Modification of Consent (Mod 1) State significant development SSD 7628

SIMTA

Modification 1

Moorebank Precinct East Stage 2 (SSD 7628)

Figure 4 Example of warehouse signage S1 and S2 (Reid Campbell, 2017)

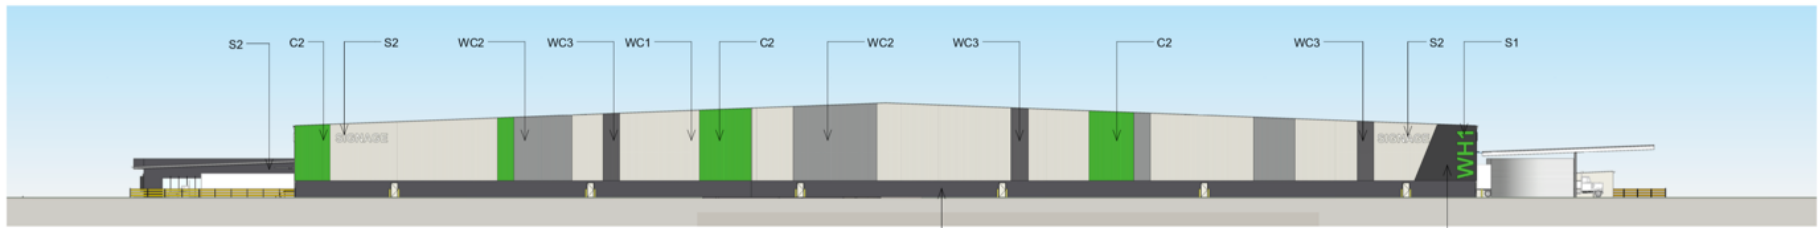
Figures 3 and 4 identify two forms of integrated building signage as S1 (Warehouse ID number) and S2 (Tenant Signage – Backlit Illuminated Signage).

Amended architectural drawings are provided in Appendix A that identify removal of backlit illuminated integrated building signage from external-facing eastern and southern elevations. Drawings included in Appendix A proposed to be modified from those presented in the EIS and Rts are presented in Table 3 below.

Drawing reference	Warehouse	Proposed Modification
115123_A_SSD_1109 and 115123_A_SSD_1112	WH2	Remove illuminated signage on east elevation
115123_A_SSD_1204 and 115123_A_SSD_1207	WH3	Remove illuminated signage on east elevation
115123_A_SSD_1209 and 115123_A_SSD_1212	WH4	Remove illuminated signage on east elevation
115123_A_SSD_1304 and 115123_A_SSD_1307	WH6	Remove illuminated signage on east elevation
115123_A_SSD_1309 and 115123_A_SSD_1310 and 115123_A_SSD_1312	WH7	Remove illuminated signage on east elevation Remove illuminated signage on south elevation
115123_A_SSD_1315 and 115123_A_SSD_1318	WH8	Remove illuminated signage on south elevation
